Detailed Justifications for
Filling and Excavation of Land for Vehicular Access Road on Government Land in D.D. 112,
Shek Kong, Yuen Long

Temporary Traffic Arrangement for Temporary Run-In Out for Construction Works at Ko Sheung Road near Nam Hing West Road

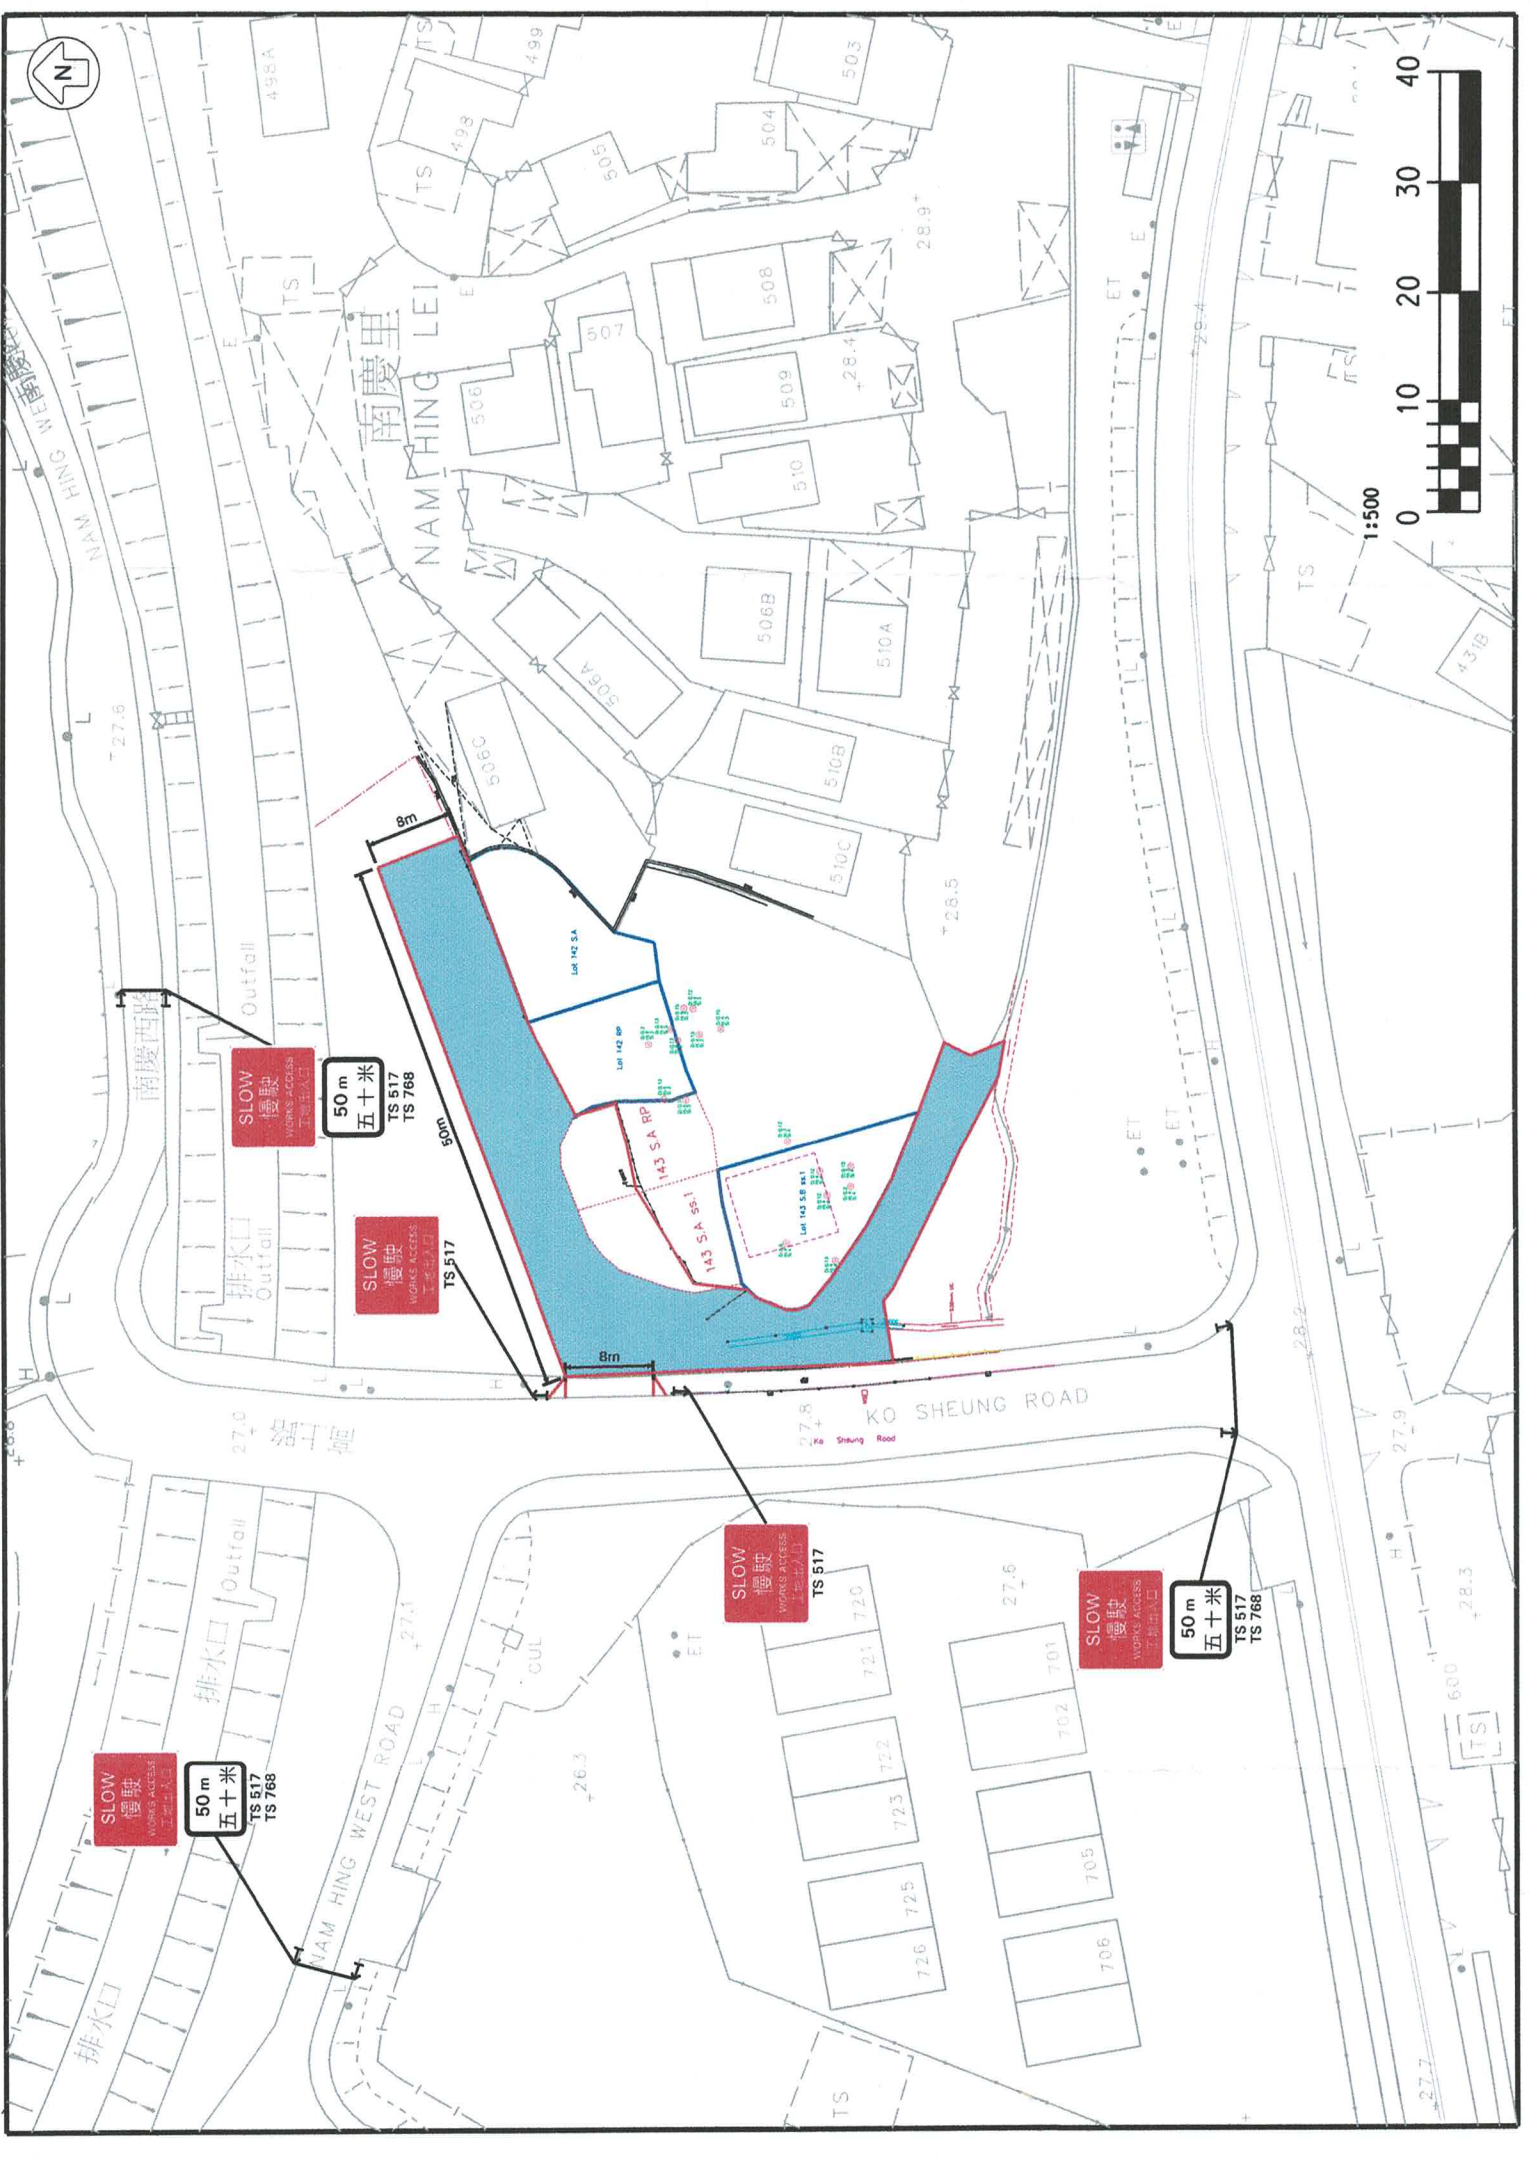
Agreed via fax (3747 3221) on 28 Aug 2024 with the following Approval Conditions :

- 1) Please liaise with locals and affected stakeholders before commencement of the proposed works.
- 2) As the works area as shown is outside the purview of TD, please verify the road/land status, seek prior comments and obtain consents from relevant managerial departments/affected parties/stakeholders.

- 3) Please provide the purpose of works area in detail.
- 4) As the proposed vehicular access/run-in/out is temporarily implemented on a footpath, please submit relevant drawing in detail to lay out the TTA for implementation of such vehicular access and pedestrian traffic control on footpath during implementation.

- 5) Please also liaise with district maintenance division of Highways Department beforehand for any removal of existing street furniture such as type II railings on the back of footpath. Such railings shall be immediately reinstated upon completion of works.

- 6) The plastic barriers as shown shall be provided with flashing lanterns for 24-hour TTA/works and shall be specified on the legend.
- 7) Water-filled barriers rather than plastic barriers shall be provided along the back of footpath when there is an adjoining slope or retaining wall underneath, please verify on site accordingly.

- 8) The both sides of vehicular access/run-in/out shall be provided with amber revolving lanterns.
- 9) Banksman shall be deployed at the vehicular access/run-in/out for manual traffic control when necessary.

- 10) Swept path analysis of construction/works vehicle for ingress/egress at the vehicular access/run-in/out shall be demonstrated.
- 11) Adequate and unobstructed sightlines shall be maintained at/near the vehicular access/run-in/out.

- 12) Please seek prior comments and obtain consent from Traffic Police.
- 13) Please ensure no other concurrent TTA scheme nearby unless prior approvals/consents granted by TD and Traffic Police.

- 14) Please revise the anticipated programme of works for six months maximum and submit application for re-endorsement every six months.
